Subject: MHI's Response to US-APWR DCD RAI No. 301-2324 Revision 1

MHI's Response to US-APWR DCD RAI No. 301-2324 Revision 1

RAI NO.: NO. 301-2324 REVISION 1

SRP SECTION: 15.01.01 – 15.01.04 – DECREASE IN FEEDWATER TEMPERATURE, INCREASE IN FEEDWATER FLOW, INCREASE IN STEAM FLOW, AND INADVERTENT OPENING OF A STEAM GENERATOR RELIEF OR SAFETY VALVE

Figure 15.1-1.1 DNBR versus Time with and without LOOP
Increase in Feedwater Flow

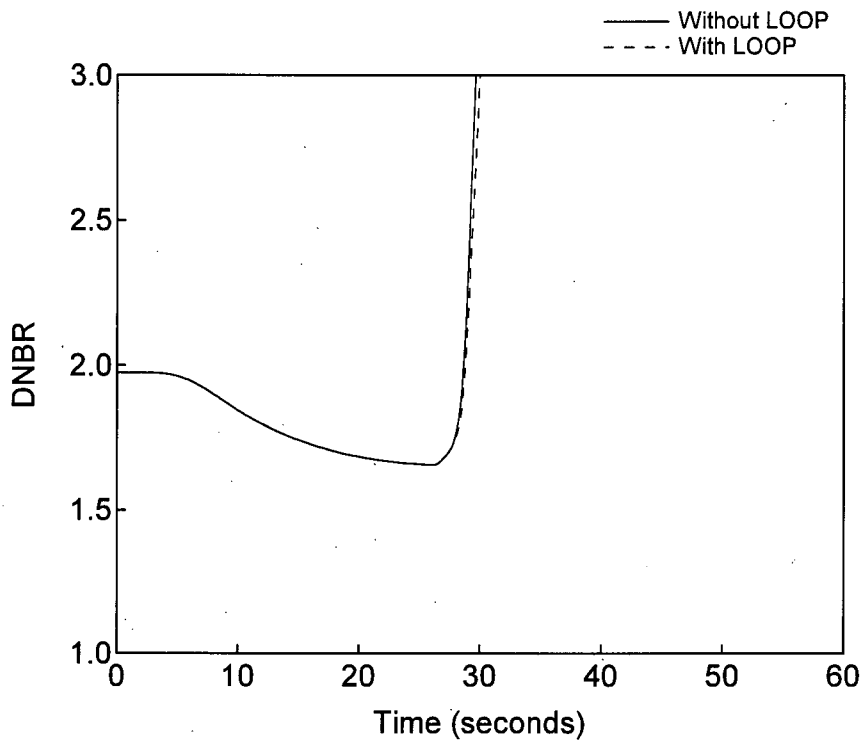
In DCD Sections 15.1.2 and 15.1.5, the applicant presents the following argument concerning the timing of a LOOP with respect to the timing of reactor or turbine trip from at-power conditions and the subsequent RCP coast down. It is used as justification for neglecting LOOP for these events with respect to the minimum DNBR and is based upon the discussion in DCD Section 15.0.0.7: "A turbine trip could cause a disturbance to the utility grid, which could, in turn, cause a loss of offsite power, which could, in turn, cause a reactor coolant pump (RCP) coastdown. As discussed in DCD Section 15.0.0.7, the resulting RCP coastdown would not start until after the time of minimum DNBR so that the minimum DNBR for the entire transient is the same whether offsite power is available or unavailable. Since the two cases have equally limiting minimum DNBRs, the case where offsite power is unavailable is not presented." The applicant should present additional technical justification as to why minimum DNBR always occurs before the LOOP, why cases where offsite power is unavailable are not presented, as well as technical justification as to why the remaining duration of the affected transients are similarly unaffected by the loss of offsite power.

A sensitivity analysis concerning the US-APWR LOOP assumptions and their supporting bases will be described in detail in the response that will be submitted for RAI 297-2287 Question 15.0.0-3. Figure 15.1-1.1 below provides the transient DNBR curve for the DCD Subsection 15.1.2 event (increase in feedwater flow) considering a LOOP, in which the reactor coolant pump coastdown is delayed 3 seconds after the turbine trip (turbine trip is assumed to occur at the same time as reactor trip). For comparison, the curve without LOOP is provided on the same figure. For the main steam line break event described in Subsection 15.1.5, cases are presented for HZP double-ended breaks both with and without LOOP (Cases A & B) and for a spectrum of breaks at HFP (Case C). The transient DNBR curve for the limiting Case C break with LOOP, in which the reactor coolant pump coastdown is delayed 3 seconds after the turbine trip (turbine trip is assumed to occur at the same time as reactor trip), is shown below in Figure 15.1-1.2. Again, the case without LOOP is also provided on the figure for comparison purposes. For the two DNBR figures shown in this response, the results are generated using the

MARVEL-M/VIPRE-01M methodology rather than the MARVEL-M lookup table methodology. Both these methodologies are described in detail in the Non-LOCA Methodology Topical Report (MUAP-07010). Since it was necessary to use the MARVEL-M/VIPRE-01M methodology for the LOOP case due to the flow coastdown, the same methodology was used for the without LOOP case for consistency. As previously described, a more detailed discussion of the bases for these two figures will be provided in the response to RAI 297-2287 Question 15.0.0-3.

Figure 15.1-1.2 DNBR versus Time with and without LOOP
Steam System Piping Failure
- Case C: Limiting case for spectrum of breaks at 100% power

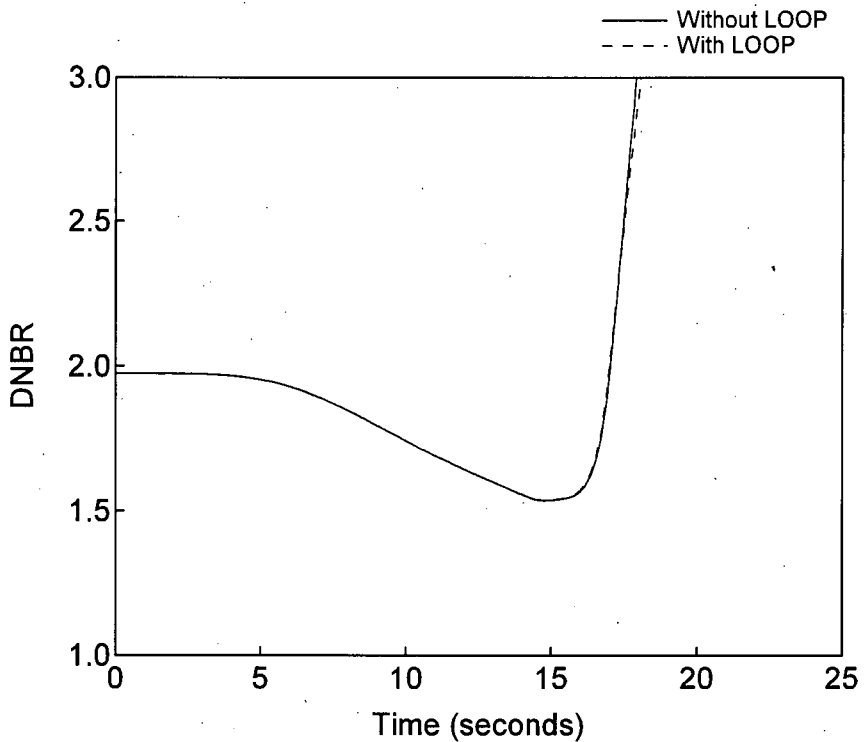
In Case C, Spectrum of Steam Break from Power Operation, provide an analysis that considers LOOP.

The basis for the effect of LOOP for Case C presented in DCD Subsection 15.1.5 (steam line break at power) will be covered by the response to RAI 297-2287 Question 15.0.0-3. The transient DNBR curve for the limiting Case C break with LOOP, in which the reactor coolant pump coastdown is delayed 3 seconds after the turbine trip (turbine trip is assumed to occur at the same time as reactor trip), has been provided in the response to Question 15.1-1 of this RAI.

Figure 15.1-3.1 Steam Generator Pressure versus Time Decrease in Feedwater Temperature

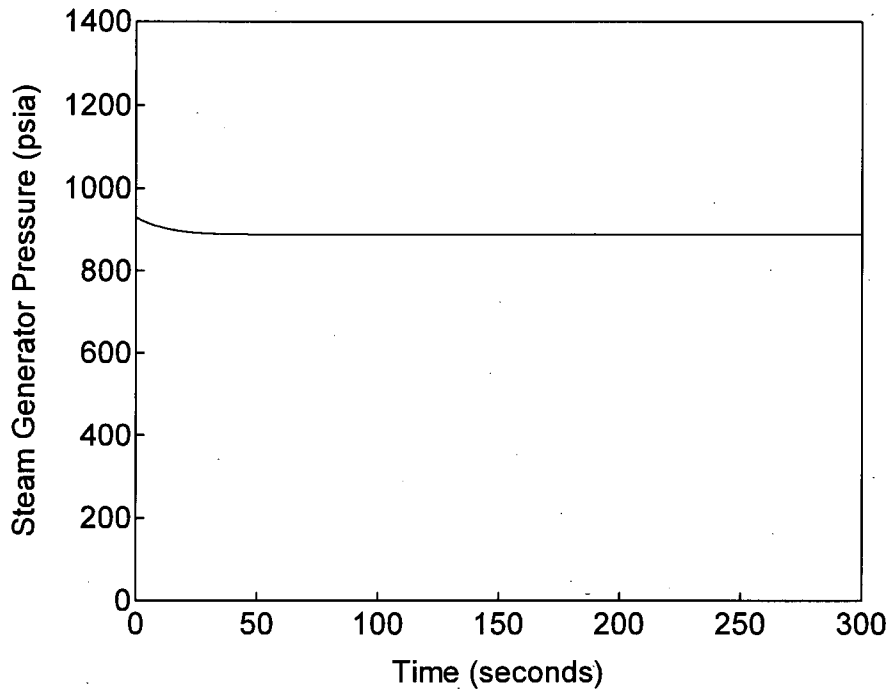
Provide transient curves for steam generator pressure verses time in Sections 15.1.1 through 15.1.3.

The transient curve for steam generator pressure versus time for the decrease in feedwater temperature analysis in DCD Subsection 15.1.1 is shown below in Figure 15.1-3.1. The transient curve for steam generator pressure versus time for the increase in feedwater flow analysis in DCD Subsection 15.1.2 is shown below in Figure 15.1-3.2. The transient curves for steam generator pressure versus time for the increase in steam flow analysis in DCD Section 15.1.3 for Cases A through D are shown below in Figures 15.1-3.3 through 15.1-3.6, respectively. These steam generator pressure figures confirm the statement in Subsections 15.1.1.3.3, 15.1.2.3.3, and 15.1.3.3.3 that steam line pressure is not a key parameter for heat removal events where steam generator pressures are stable or decreasing.
